## ADDENDUM No. 1

PROJECT: **City of Joliet, 2016 Haldemann Terrace Lateral Point Repairs**

### **THE FOLLOWING CHANGES/CLARIFICATIONS HAVE BEEN MADE TO THE PLANS AND SPECIFICATIONS:**

# Lateral Point Repair #1

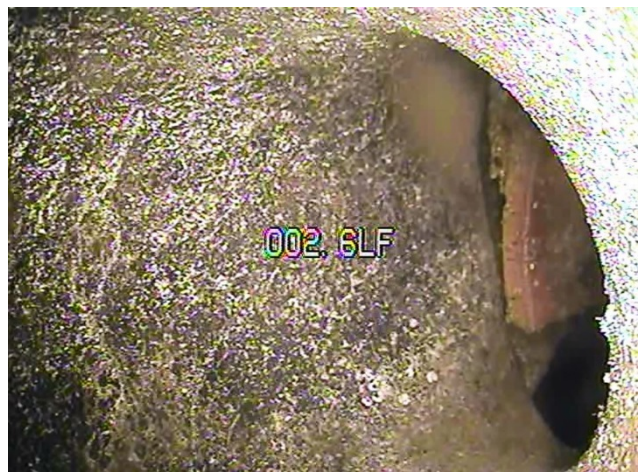
1. In the Appendix A, Lateral Point Repair 1: 810 Grand: the point repair location photos have been replaced with photos that have a green flag locating the spot of the repair. Remove and replace the original Appendix A, Point Repair 1: 810 Grand with the attached Appendix A, Point Repair 1: 810 Grand.
